Objection to Advertisement Application PL/2026/03702

Cannings Hill Garage, Horton Road, Devizes, SN10 2JG

Internally illuminated building signage, PAY/COLLECT booth lettering, digital booth screen and soffit lighting

Objector: Paul Howlett

Figure 1 — The PL/2026/03702 signage package (illuminated building signage, PAY/COLLECT lettering, digital booth screen and soffit lighting) shown within the cumulative illuminated frontage across the A361, in relation to Elder; based on the applicant's submitted drawings and signage elevations.

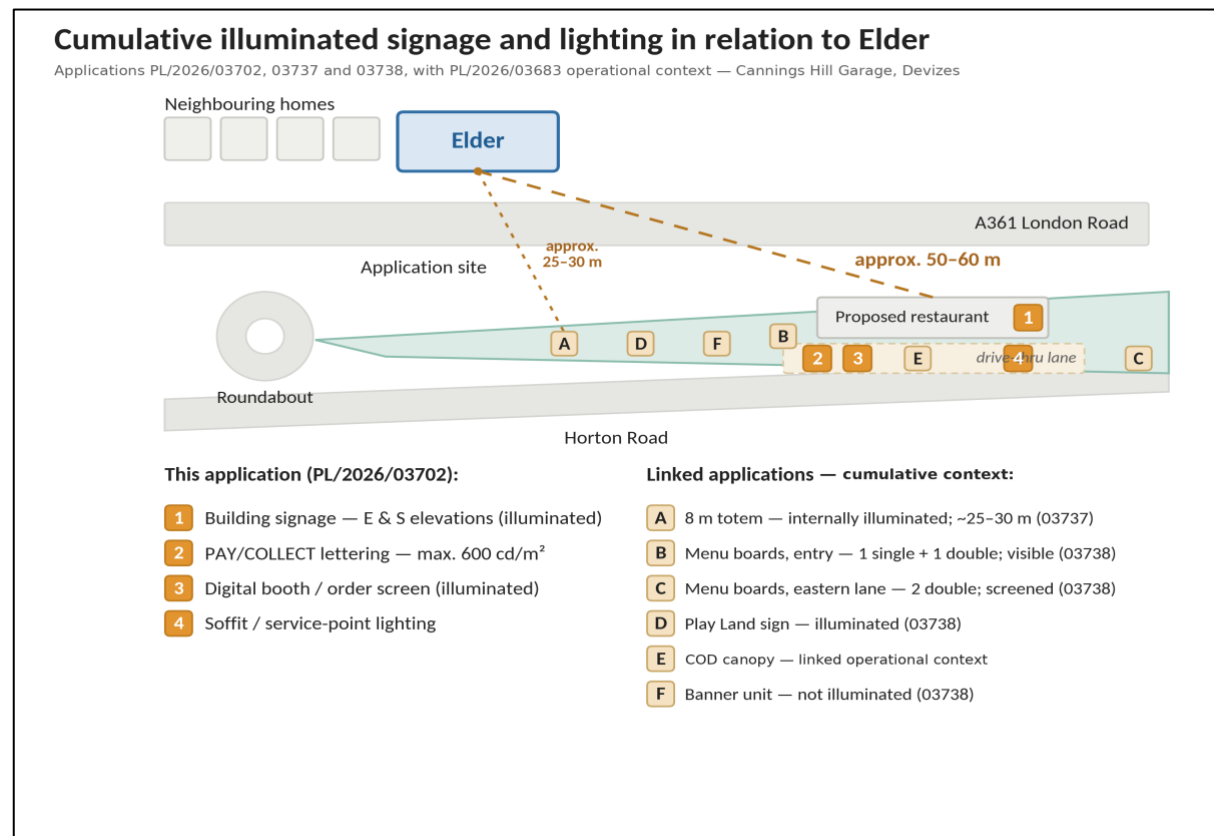
- The building signage (item 1) reflects the Building Signage Elevations drawing (9045-SA-2029-P009), which shows illuminated signage to the east and south elevations only. The PL/2026/03702 application form additionally lists signage to the north elevation, which does not appear on that drawing (addressed at Section 9 of this objection and Section 11 of the objection to PL/2026/03683).

- The PAY/COLLECT lettering (item 2) is shown at 600 cd/m², the maximum on the PAY/COLLECT drawing; the P009 sign schedule **and** the application form give 500 cd/m² for the same element. The submitted documents are internally inconsistent as to its luminance.

- The COD canopy (item E) carries a fluorescent tube and illuminated lettering; no luminance value is stated for it in any submitted document.
- The banner unit (item F) is understood not to be internally illuminated; the applicant should confirm. The entry menu boards (item B — one single, one double) would be visible from Elder; the two double boards in the eastern lane (item C) would be screened by the building.

- The 8 m totem (item A) is internally illuminated and stands approximately 25–30 m from the nearest visible part of Elder’s residential façade; in Figure 2 it is shown behind the frontage relative to the roundabout approach.
